# UNITED STATES PATENT AND TRADEMARK OFFICE

10/689,247

**Office Action Summary**

## DETAILED ACTION

FIG. 9

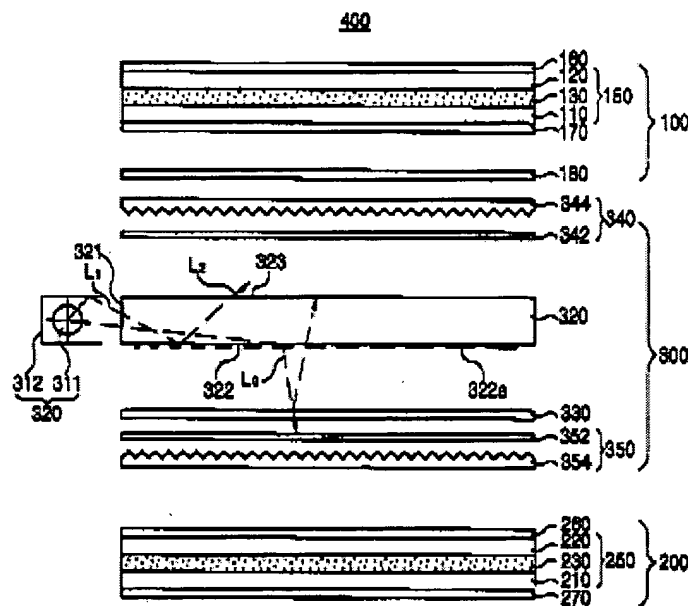
5. Choi discloses and shows in Fig. 1, a double-sided emissive LCD module comprising:

- a double-sided illumination plate ;
- a first LCD display panel (250) disposed at an upper surface of the double-sided illumination plate;

- a second LCD display panel (150) disposed at a lower surface of the double-sided illumination plate;

the double-sided illumination plate comprising:

- a light source (311);
- a light guide plate (320) for emitting light guided from the light source onto the first and second surfaces; and
- a transflector (180) disposed on a surface of the light guide plate (320) facing the second LCD panel (150),

wherein the transflector reflects a part of the light emitted from the light guide plate to the first LCD panel and transmits the rest of the light to the second LCD panel.

As to claim 4, Choi also shows in Fig. 9 that a prism sheet (354) is disposed between the double-sided illumination plate and the first LCD panel (250).
